# 471 WEST CONGRESS STREET

## RIO NUEVO – SPECIAL DISTRICT REVIEW

Re: 471 W. Congress; RNA DRB Official Submittal (TD-DEV-0523-00242); Project Narrative and Design Narrative

Illustrative Shade Study Site Plan

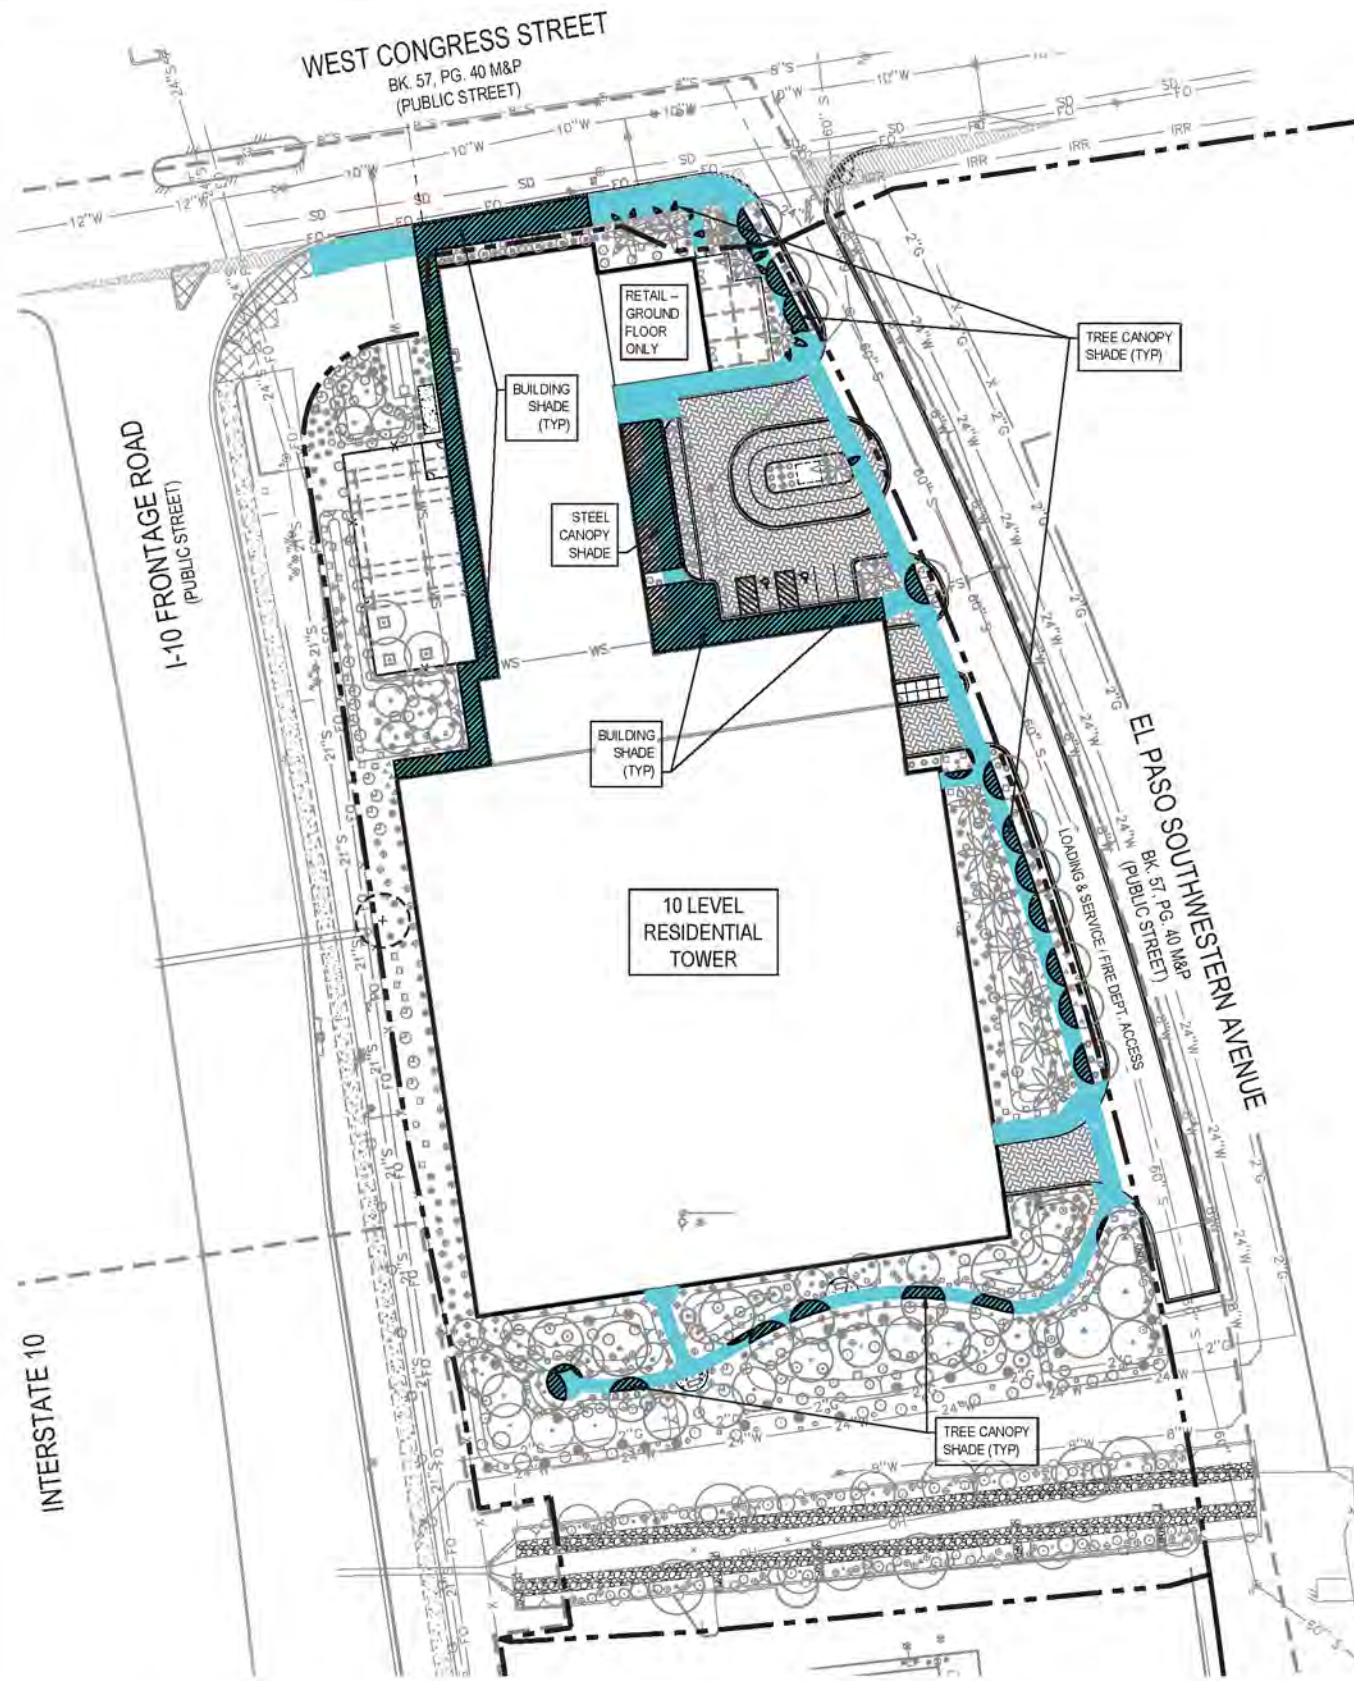
JUNE 21 SHADE STUDY: PLEASE PROVIDE SQUARE FOOTAGES AND % CALCULATIONS DEMONSTRATING COMPLIANCE WITH UDC § 5.12.7.D.4.B, WHICH READS:

SHADE EXCEPT AS PROVIDED BELOW, SHADE SHALL BE PROVIDED FOR AT LEAST 50% OF ALL SIDEWALKS AND PEDESTRIAN ACCESS PATHS AS MEASURED AT 12:00 P.M. ON JUNE 21 WHEN THE SUN IS 80 DEGREES ABOVE THE HORIZON. SHADE MAY BE PROVIDED BY TREES, ARCADES, CANOPIES, OR SHADE STRUCTURES, PROVIDED THEIR LOCATION AND DESIGN CHARACTERISTICS ARE COMPATIBLE WITH THE HISTORIC AND DESIGN CONTEXT OF THE STREET AND THE ARCHITECTURAL INTEGRITY OF THE BUILDING. THE USE OF PLANTINGS AND SHADE STRUCTURES IN THE CITY RIGHT-OF-WAY IS PERMITTED TO MEET THIS STANDARD WITH THE APPROVAL OF THE TRANSPORTATION DEPARTMENT. THE SHADE PROVIDED BY A BUILDING MAY SERVE TO MEET THIS STANDARD.

-  SIDEWALKS AND PEDESTRIAN ACCESS PATHS = 13,957 S.F.
-  BUILDING, BUILDING CANOPY AND TREE CANOPY SHADE AT 12:00 P.M. ON JUNE 21ST. = 7,731 S.F.

TOTAL SHADE REQUIRED = 50%  
 TOTAL SIDEWALKS AND PEDESTRIAN ACCESS PATHS = 13,957 S.F.  
 TOTAL BUILDING, BUILDING CANOPY AND TREE CANOPY SHADE = 7,731 S.F.

$7,731 \text{ S.F.} / 13,957 \text{ S.F.} = 0.55$  OR **55% SHADE PROVIDED**
